**ADDENDUM TO THE
TECHNICAL DRAINAGE STUDY
FOR
DUNCAN LEON COMMERCIAL**

**Date
March 1, 2021**

**Project Number
20-0014**

Subject: Addendum to the Technical Drainage Study for Duncan Leon Commercial
(CLV No.: 5417)
(APN 138-12-110-051)

HS-2, HS-3, & HS-4

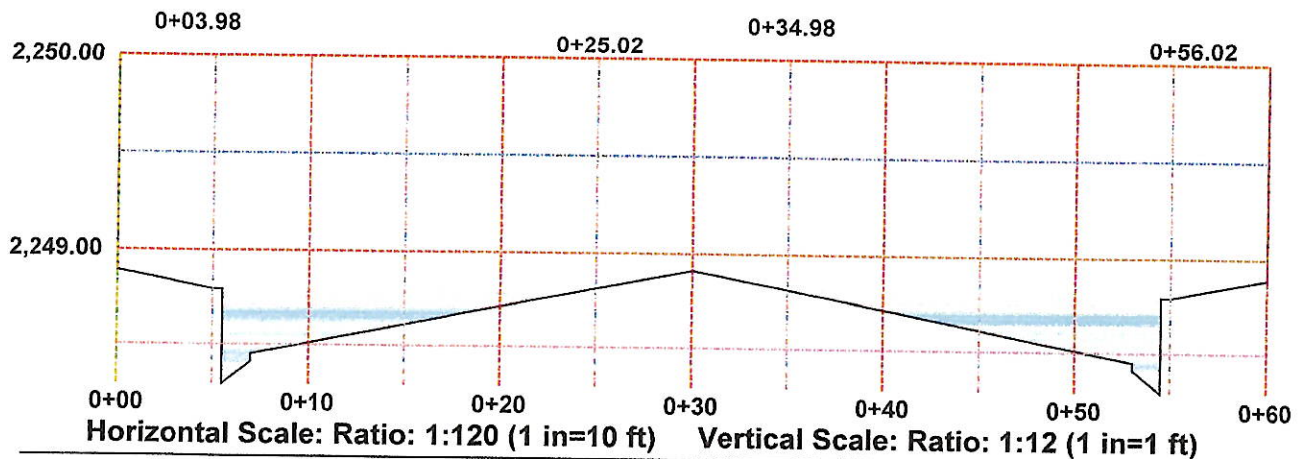
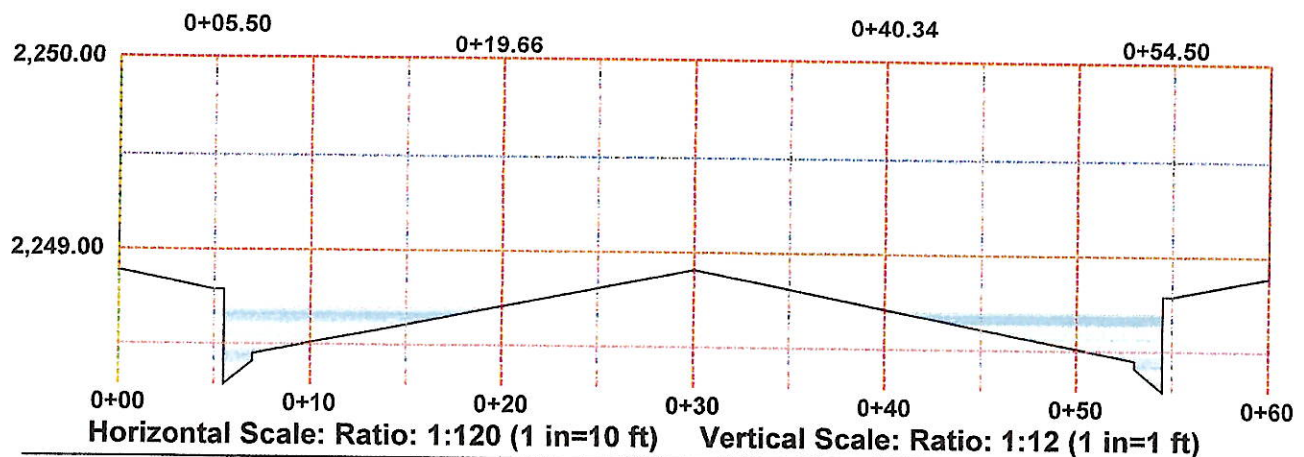
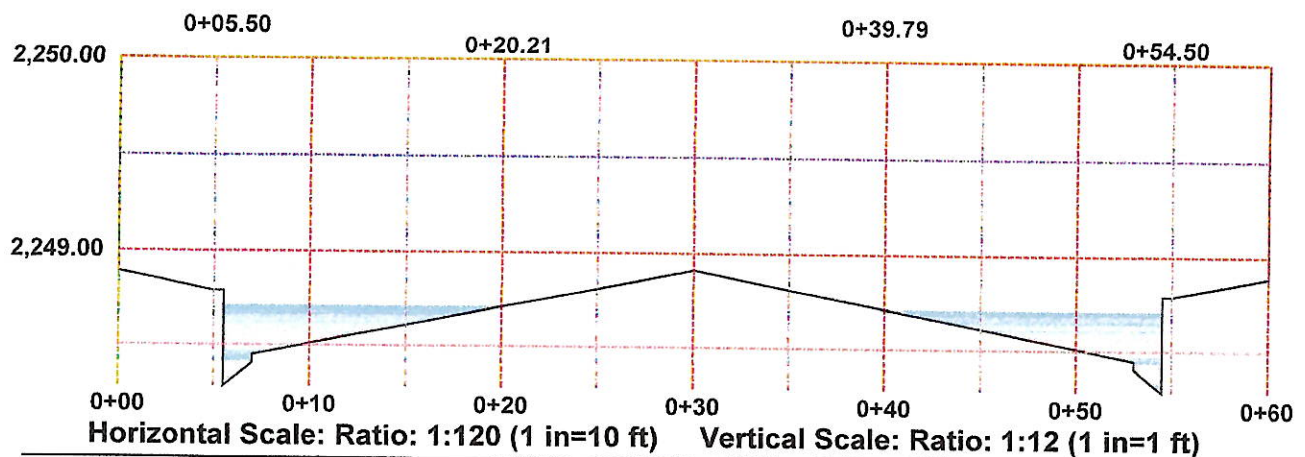
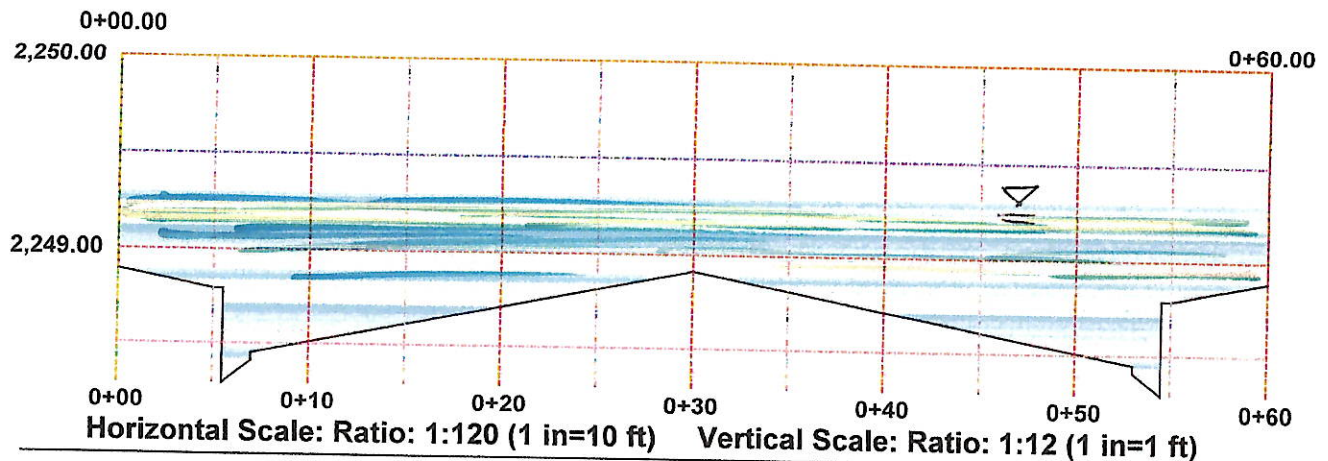
6. The adopted FEMA flow within Duncan is 206 cfs at Rancho per the Rancho/US95 FIS. Adjust the flow rate impacting the site to include Basin OFF-A for a total of 226 cfs within the Street Section for the 100-year event. Update the Report narrative and Tables accordingly. Use the critical depth from the Street flow calculations to establish the Base Flood Elevation (BFE), as FEMA looks at sub-critical flow regime. Update the Street flow depth calculations accordingly. This sets the BFE based upon the entire flow within the Street Right-of-Way.

8. Revise the Street flow calculations to reflect an n-value of 0.016 per the HCDDM requirements. Flood Control estimates the flow at critical depth to be nearer to 1.2-feet. Review the calculations and all exhibits and show the revised flow depths accordingly. This will affect the Site Grading and Proposed Building Finish Floor Elevation (FFE). The FFE must be a minimum of 18-inches above the BFE.

Response: The Street Capacity Analysis has been updated with the entire flow of 226-cfs. The Street Capacity Analysis is included in the Appendix and summarized in the Table below. Also attached are both the updated Existing Drainage Basin Map and the Developed Drainage Basin Map.

Response: Attached is the revised Street Flow Calculations reflecting the n-value of 0.016. The Finished Floor Elevation has been raised to 2250.90 (Minimum of 18" above the BFE) (See attached Grading Plan).

EXISTING DRAINAGE BASIN

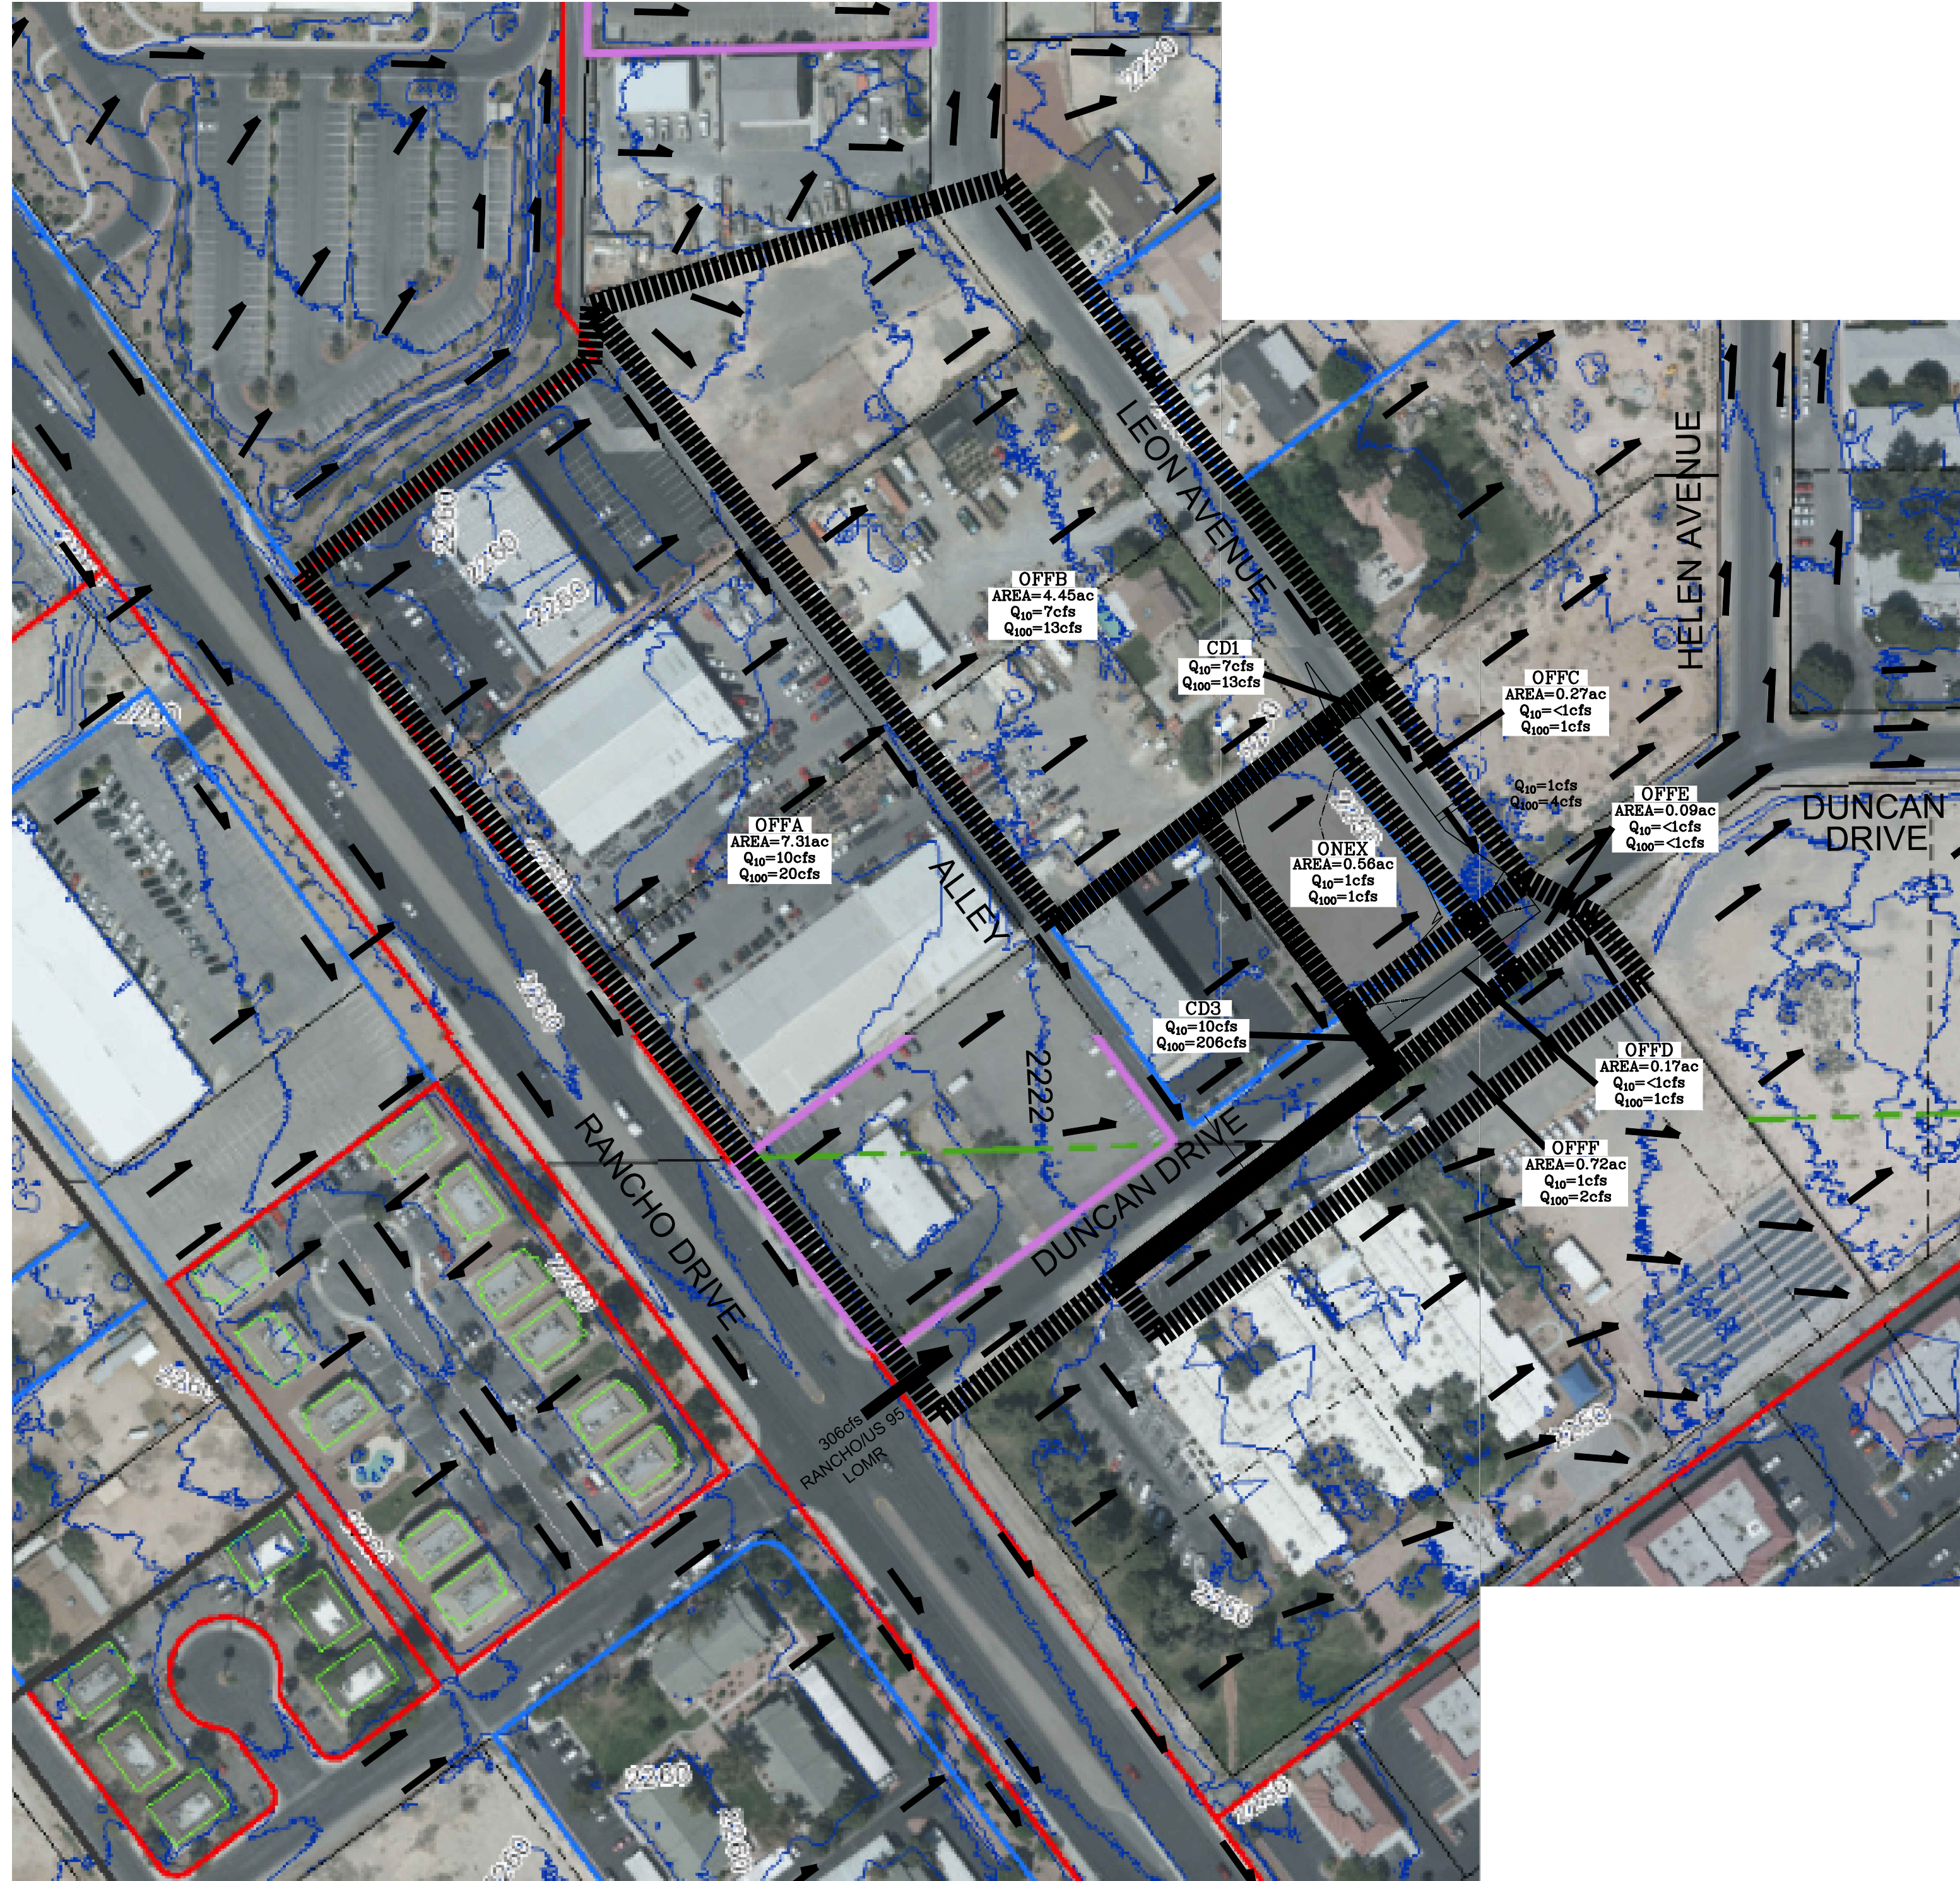
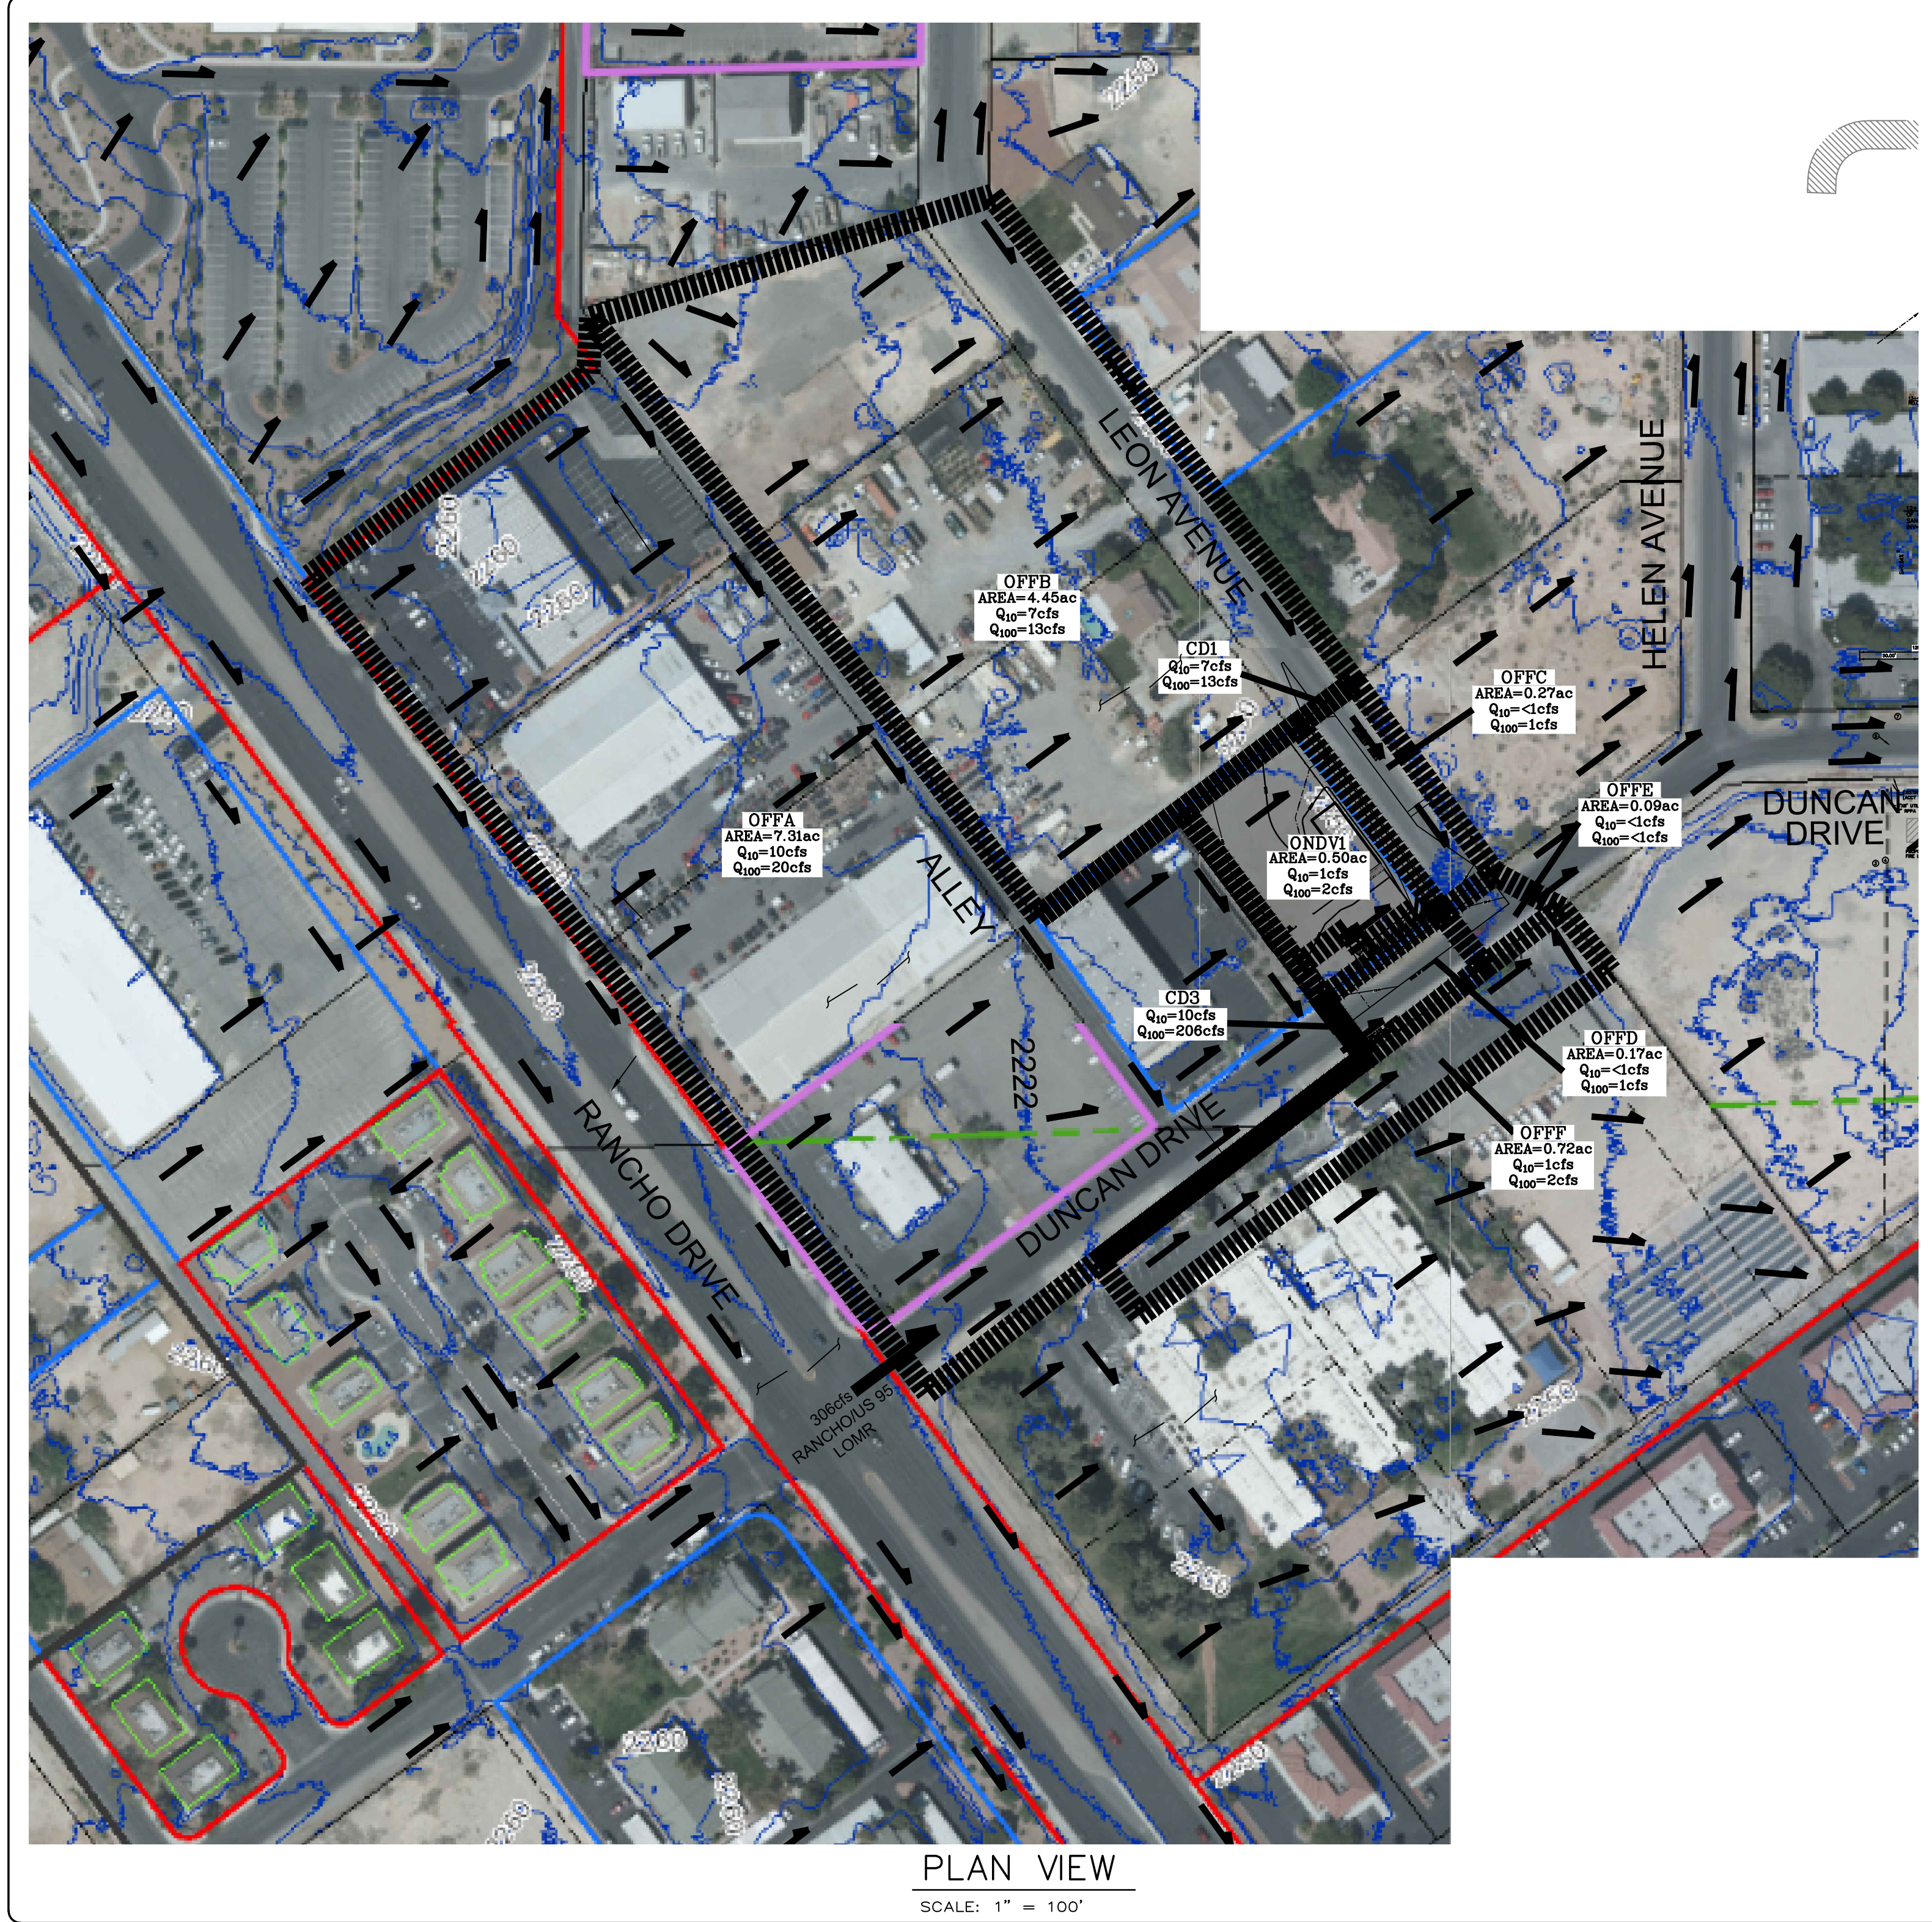
7. Update Figure 5 & 6 to reflect the 206 cfs at the Rancho Intersection and 226 cfs at the site.

Response: Updated Figures 5 & 6 are attached.
